Addendum No. 001

Subject: Mechanical Plant Replacement Bid Package
Mechanical
SDP Contract No. B-045 (c) of 2017/18

Location: Arts Academy at Benjamin Rush
11081 Knights Road
Philadelphia, Pennsylvania 19154

DRAWING NO.
M100

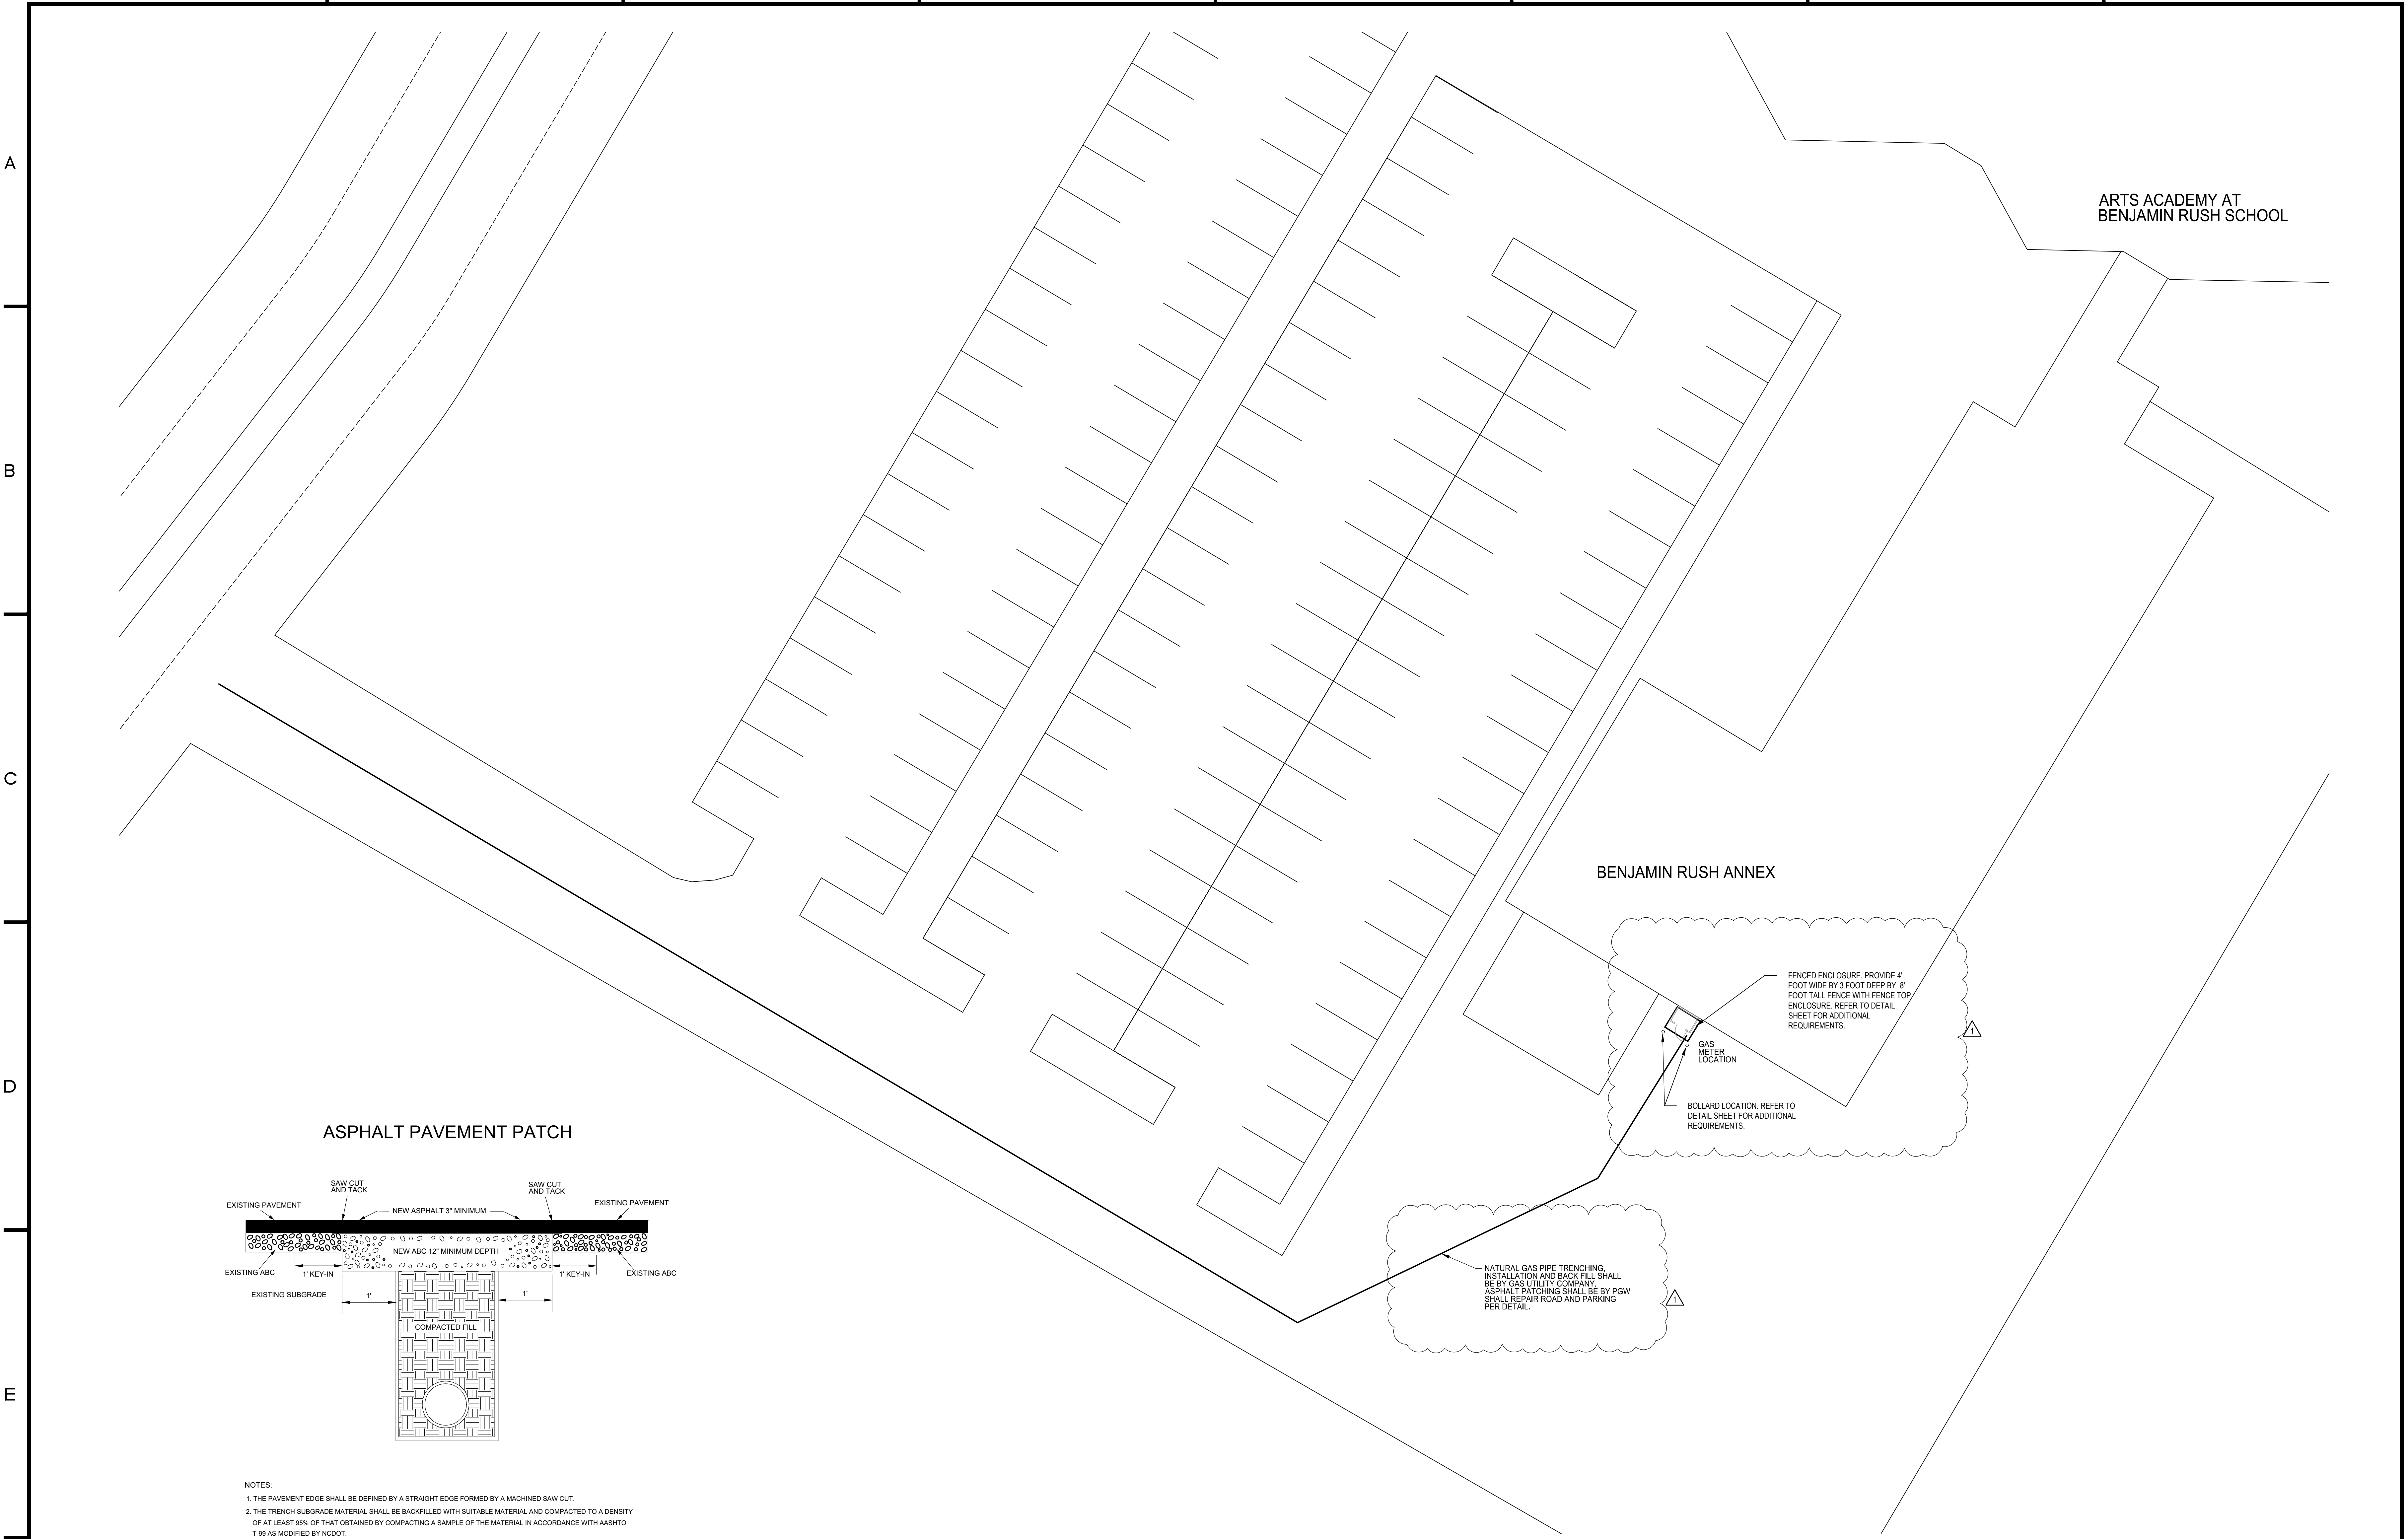
- 2.1.5** Drawing revision M100 – Added noting for M.C. responsibility for all roof work associated with the installation of the roof curbs and rooftop units. Added noting for pipe roof supports.

DRAWING NO.
M101

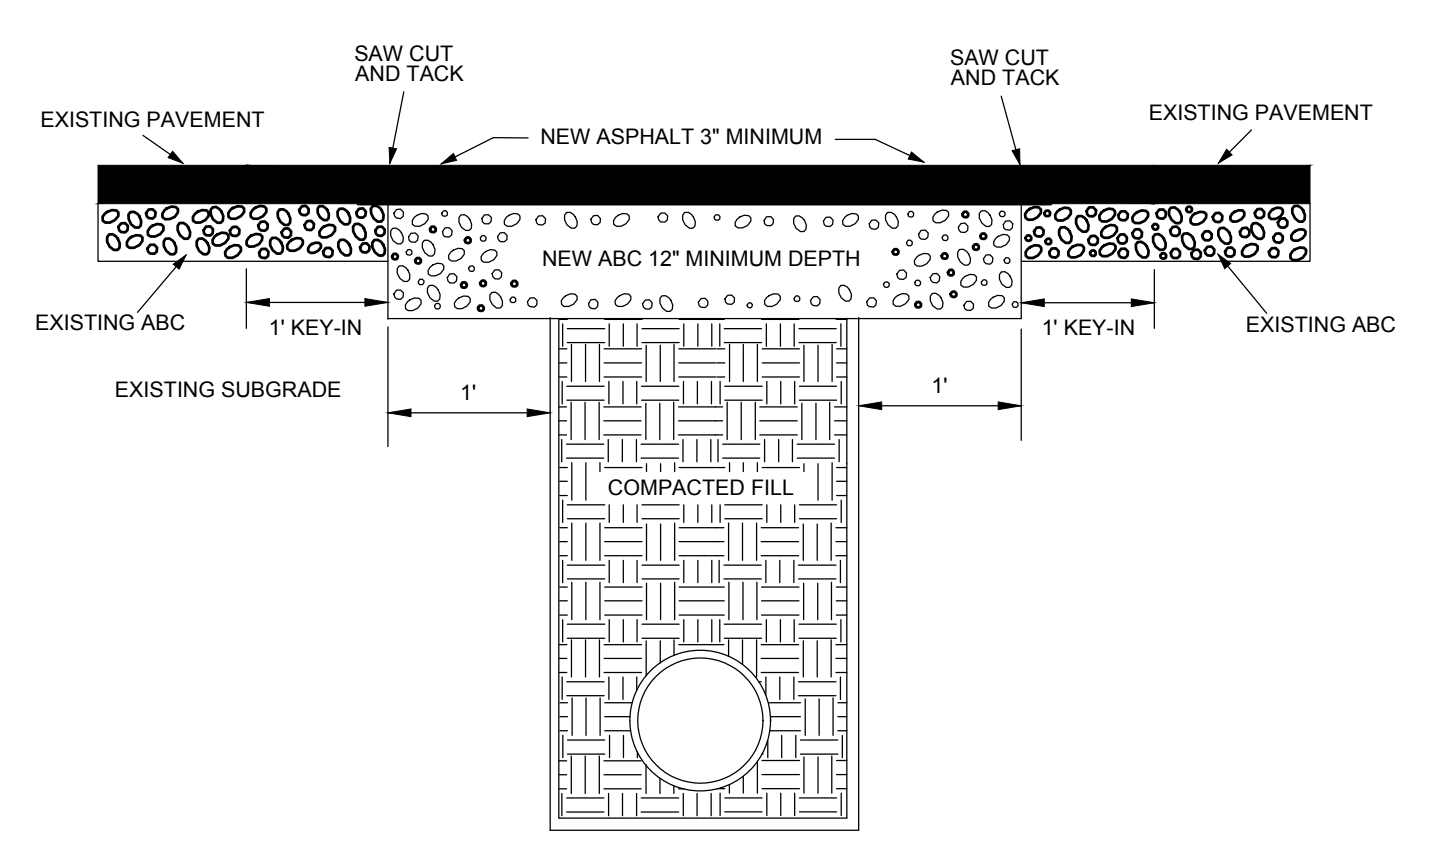
- 2.1.6** Drawing revision M101 – Revised note for asphalt patching/repair to be by PGW. Added noting for chain link enclosure around meter and bollard protection.

3.1.7 Please confirm that all work from the street to the downstream side of the gas meter is by the gas utility company with the exception that the mechanical contractor is responsible to patch the asphalt.

- Refer to 2.1.6 above. Asphalt patching repair to be by PGW
